U.S. Nuclear Regulatory Commission

Research Information Letter 12-01

Confirmatory Analysis of Seismic Hazard at the
Diablo Canyon Power Plant from the Shoreline Fault Zone

September 2012

Figure 4-2 Lateral extent of characteristic earthquake rupture scenarios considered as viable possibilities in this report.

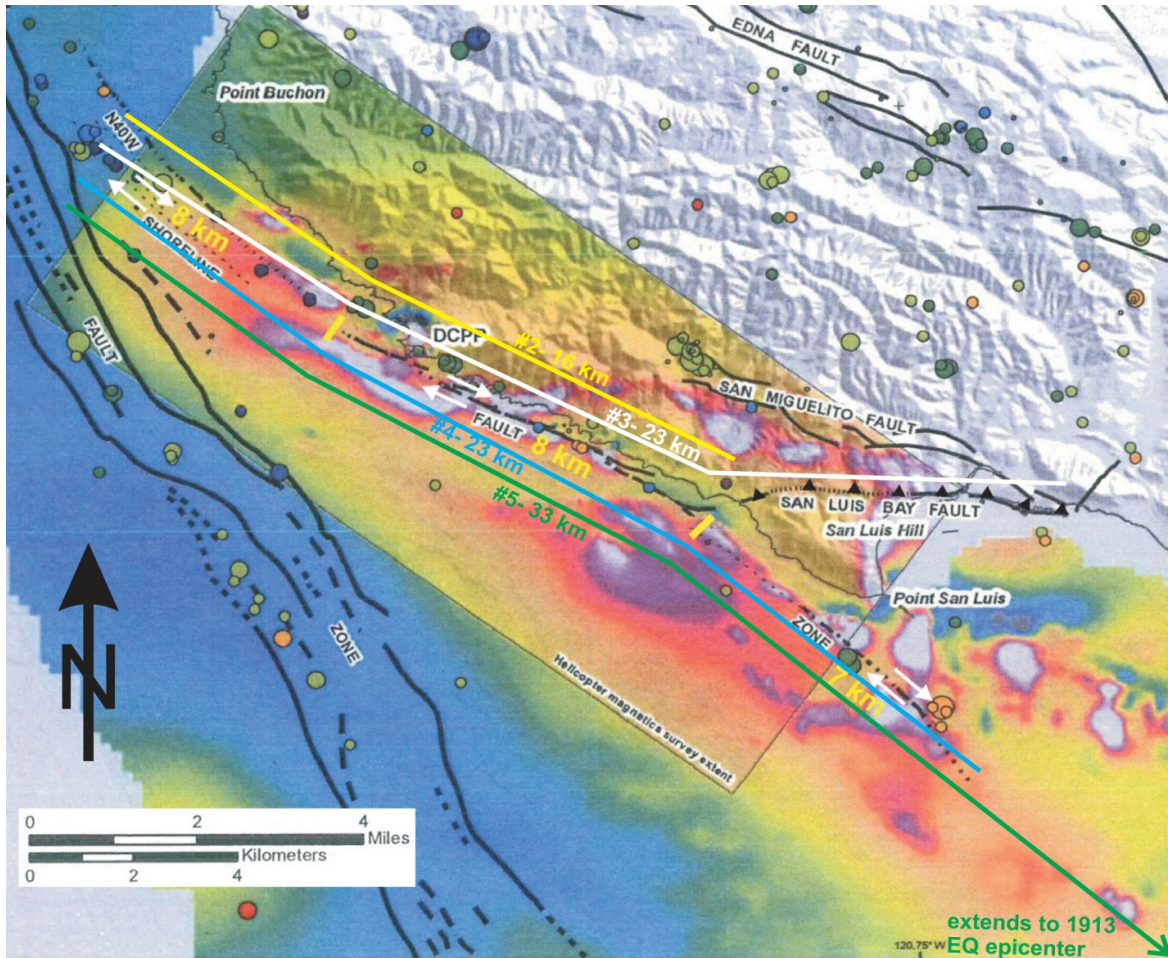
The NRC developed five alternative interpretations to characterize the Shoreline fault (summarized in Table 4-1) based on the available data. Figure 4-2 shows these five scenarios overlain on Figure 4-17 of the Shoreline Fault Report. Some of these scenarios used combinations of the same segments identified by PG&E. However, the NRC did not consider scenarios in which the segments acted independently. The magnitudes in these five scenarios range from less than M5.9 to M6.9. Considering all available information, the NRC concludes that two deterministic assessments are needed to reasonably assess the potential impact of the Shoreline fault seismicity on the overall DCP seismic hazard assessment. The first assessment is based on Scenario 1, in which the Shoreline fault is deemed to be a creeping fault and capable of producing smaller magnitude earthquakes up to M5.9. A magnitude M5.9 was selected as a reasonable upper-bound magnitude earthquake on the Shoreline fault that

As described above, this interpretation is supported by the recorded seismicity, coupled with the lack of visible offset along the fault. The remaining scenarios (shown in Figure 4-2) ignore the discrepancy related to the lack of surface expression because deterministic analyses do not explicitly consider slip rate, likelihood, and other data tied to the probability of the Scenario Earthquake of interest occurring. The remaining discussion in this Section considers whether a scenario is likely to be plausible, not the likelihood of the event.

In this interpretation, the entire mapped trace of the south segment of the Shoreline fault lies along a magnetic lineament (see Figure 4-2). PG&E (2011, Plate 1) arbitrarily ended the fault at the farthest southeast “pick of faults and fold axes interpreted from shallow seismic survey lines,” but the magnetic lineament continues at least another 5 km farther southeast. On Plate 1 of the Shoreline Fault Report, PG&E shows three “picks of faults and fold axes interpreted from shallow seismic survey lines” lying along the projection of the south segment of the Shoreline fault that are not ascribed to any particular fault zone (shown as small yellow squares in Figure 4-7). Two of these “picks” lie at 5.8 km and 6.7 km southeast of the end of the Shoreline fault as mapped by PG&E in the Shoreline Fault Report. A line connecting the two picks trends N 35° W. If that line is projected to the northwest, it comes much closer to the Shoreline fault than to any other fault mapped by PG&E (2011). Under this scenario, the maximum the Shoreline fault can be extended is 13 km southeast of PG&E’s current mapped terminus. Otherwise, the fault trace would come onshore, and there is no evidence for an onshore Quaternary fault that can be linked to the Shoreline fault. Thus, the maximum permissible length of the Shoreline fault is 36 km. However, we also note that there has been no clustered microseismicity in the period from 1988 to 2008 along the proposed 10 km extension of the south segment. Therefore, even if the Shoreline fault exists there as an old (Tertiary) fault, there is no evidence it has been reactivated in the Quaternary except for the possibility that the 1913 earthquakes occurred on it. The epicenter of the 1913 earthquake is highly uncertain and could have occurred on several of the Southwestern Boundary zone faults, including the Pecho, Los Berros, or Oceano faults. Therefore, although the scenario has been hypothesized as one representing the maximum permissible length, it is not supported as well as other scenarios by the data.

Figure 4-3 Seismicity and recurrence curves for the Shoreline fault (Figure 4-3 of the PG&E Shoreline Fault Report, annotated with the curves appropriate for a creeping fault).

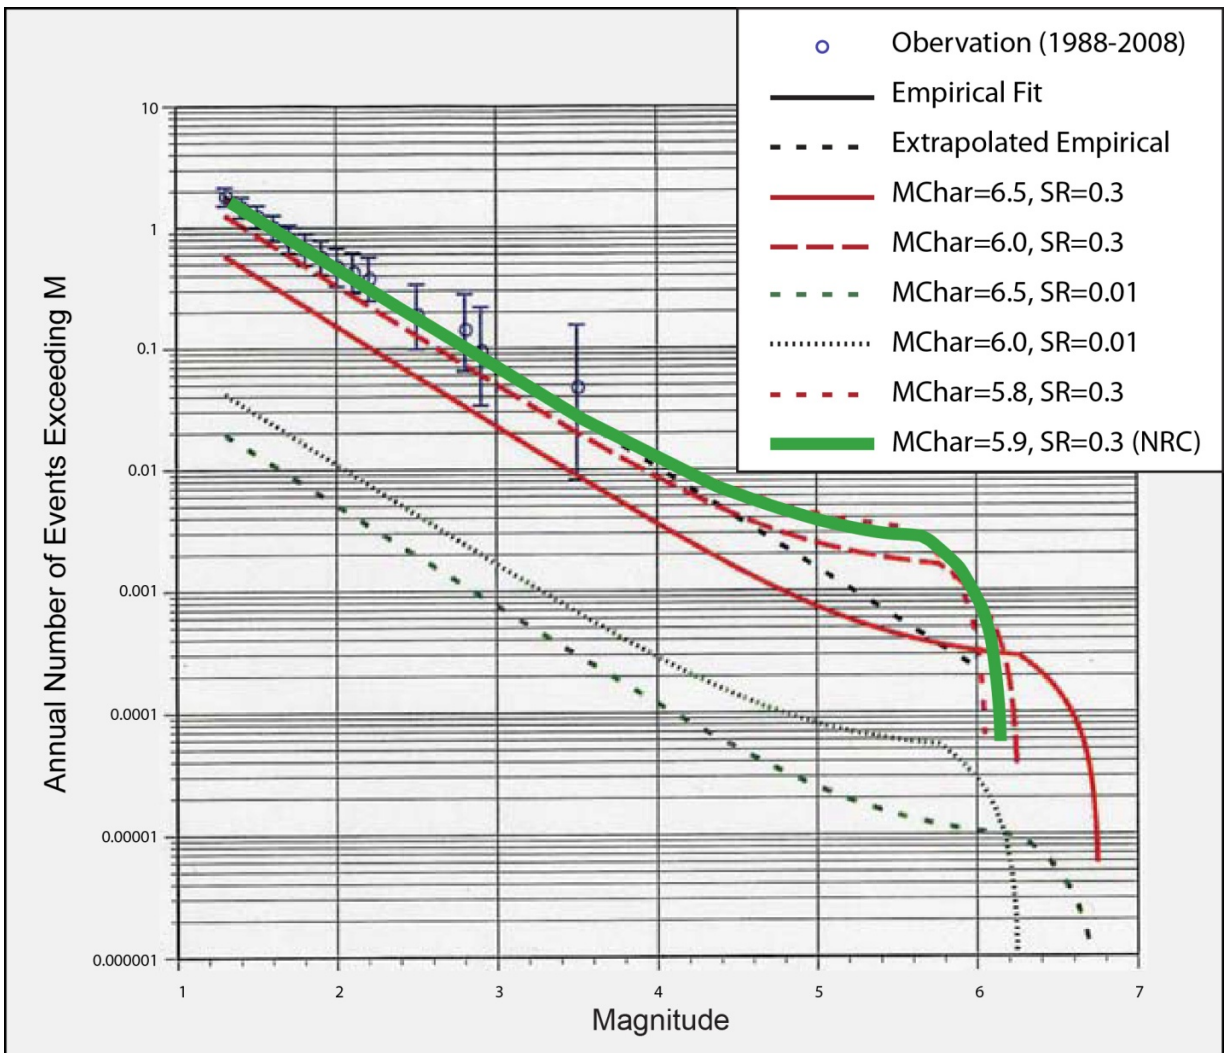
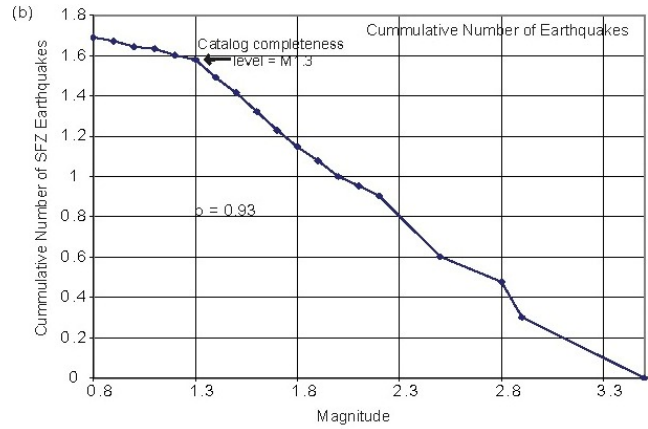
Figure 4-3 in this document is an annotated version of Figure 4-3 in the Shoreline Fault Report. This figure shows the number of earthquakes recorded per year (in the upper left), the cumulative number of earthquakes recorded in each magnitude bin (in the upper right) and the calculated catalog completeness, and the magnitude recurrence curves for various maximum magnitudes and slip rates overlain on the recorded data (in the lower half). However, none of the characteristic magnitude/slip rate combinations shown in Figure 4-3 fit the data when the lack of observed surface displacement is considered. Instead, the current rate of seismicity of small earthquakes and the lack of visible offset would be explained by a combination of a lower characteristic magnitude and lower slip rate. This supports a Shoreline fault model with a smaller M_{max} .

Figure 5-6 Shear wave velocity profiles from 1978 downhole measurements (Figure 5-5 in DCPD LTSP Report, with annotation by the NRC Staff (from RIL 09-001)).

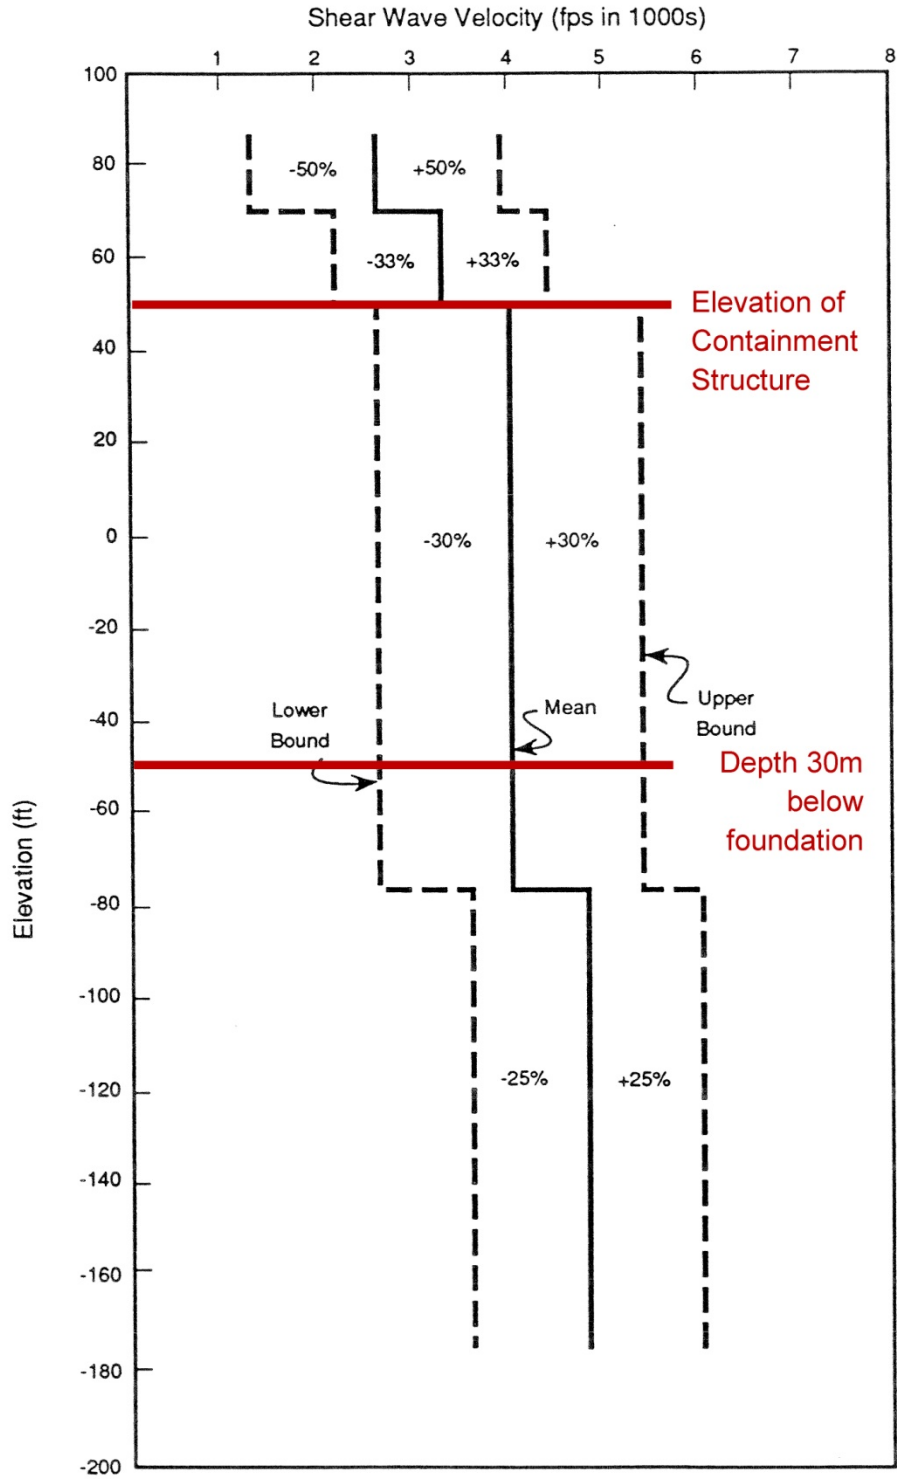
Using Figure 5-6 and accounting for the foundation depth, in the 2009 study, the staff determined that the best estimate of V_{S30} at the site was 1,100 m/s and the best estimate of $Z_{1.0}$ was 0 m, as shown in Table 5-5. The upper and lower bound values used in the parametric study in RIL 09-001 are also shown in the table. Information to directly determine $Z_{2.5}$ was not available. As a result, the staff used the estimation techniques described in Campbell and Bozorgnia (2007).

Figure 5-6 shows that $Z_{1.5}$ (the depth to 1.5 km/s) is 40 m in the best-estimate profile. Because higher values of $Z_{2.5}$ are conservative and, functionally, any value between 1.0 km and 3.0 km is treated the same in the GMPE, the default value of 2 km provided by Campbell and Bozorgnia (2007) was used.

Figure 5-7 Comparison of 2010 DCPD ISFSI velocity profiles to that of the 1978 velocity profile.

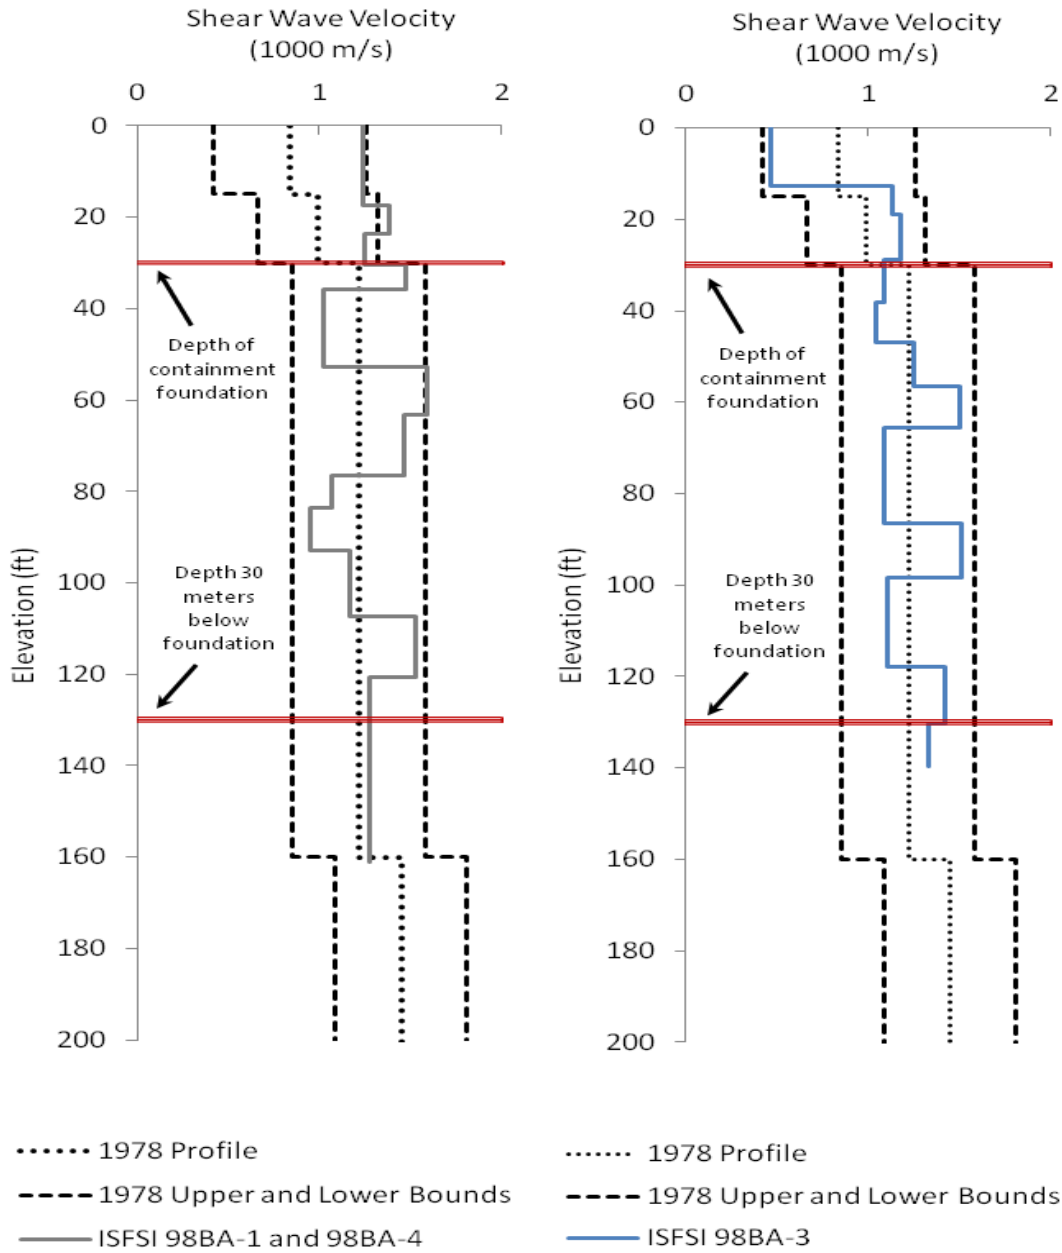
Using the ISFSI data, the NRC performed a review comparing the shear-wave velocity profiles obtained for the DCPD in 1978 to those of the DCPD ISFSI profiles collected in 2010, as shown in Figure 5-7. The objective of the analysis was to develop a best estimate of V_{S30} from the data obtained in 2010 using current methods and state-of-the-art equipment, and then to compare the results of the new study against the results of the 1978 study, which the NRC staff used in the preliminary analysis described in RIL 09-001.

Figure 5-11 Comparison of recording from 2003 San Simeon Earthquake at DCPP with predicted median ground motions from Graizer and Kalkan (2009) with and without site response correction factors of Silva (2008).

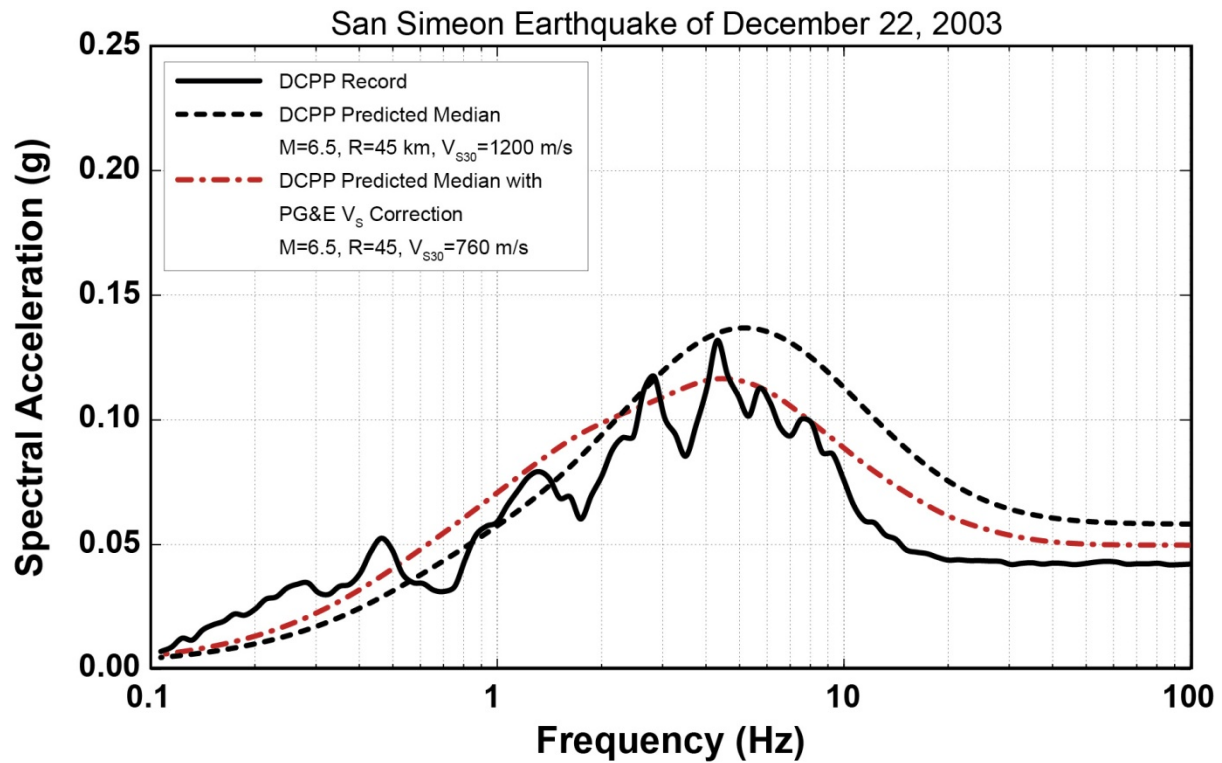
Figure 5-11 and Figure 5-12 present comparisons of the same DCPD recordings and the median ground motion prediction results of Graizer and Kalkan (2009) for two cases. One incorporates the shear-wave velocity based site response correction factors of Silva (2008) assumed for the site presented in Table 5-6 and described in Section 5.7.1, while the other uses V_{S30} directly in the GMPE. It can be seen that, in this instance, the site response based correction factors provide better agreement between the observations and the median⁵ estimates, particularly for the high-frequency portion of the spectrum.

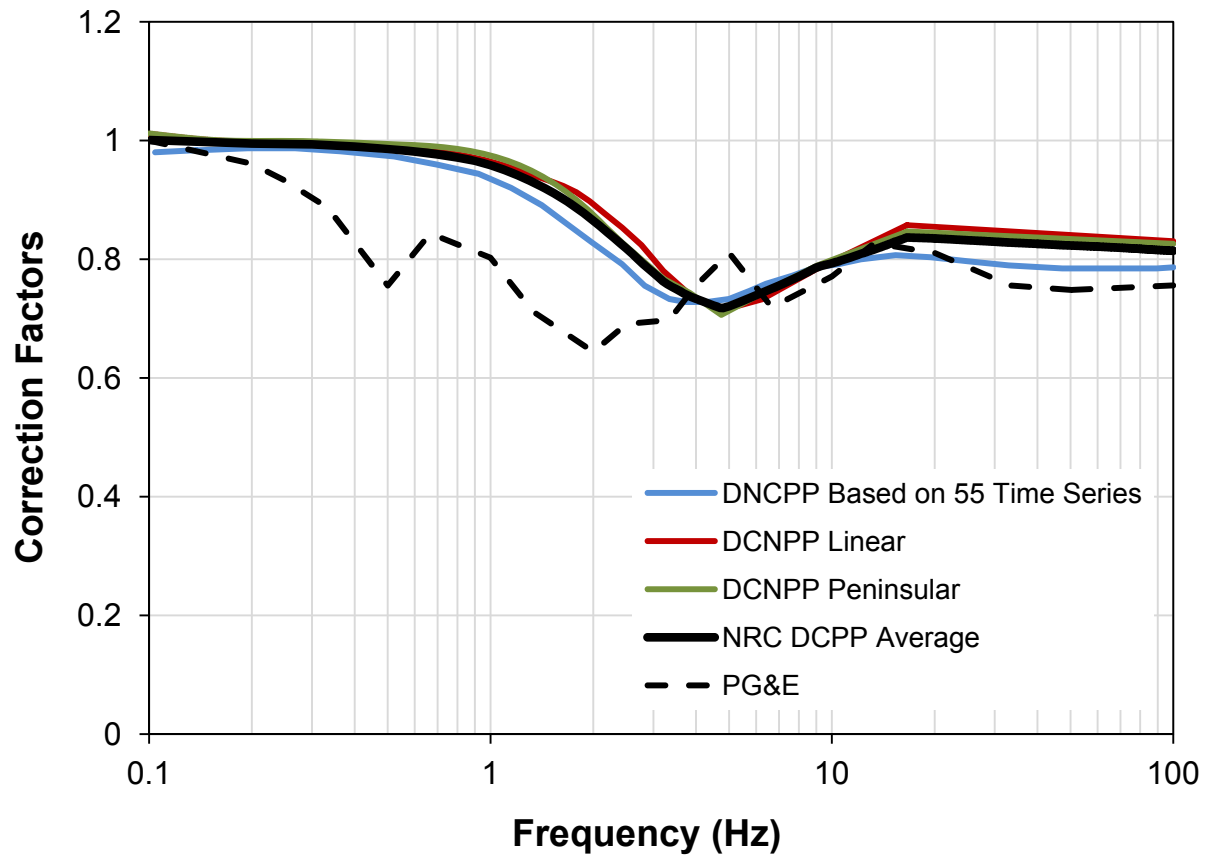
Figure B-8 compares the resulting correction factors for the time-series (TS) based approach and the RVT-based approach to those used by PG&E in the Shoreline Fault report. The results obtained using the TS and RVT approaches do not differ significantly from each other in this case. Since these two approaches represent two different, but both plausible, methodologies to perform this assessment, the NRC staff simply computed the arithmetic average of the three results to use in the deterministic analysis (shown as the heavy black line in Figure B-8). The correction factors used by PG&E in the Shoreline Fault Report are also shown in Figure B-8 as the dashed black line. As can be seen in Figure B-8, the NRC results are conservative relative to the PG&E results at virtually all frequencies.
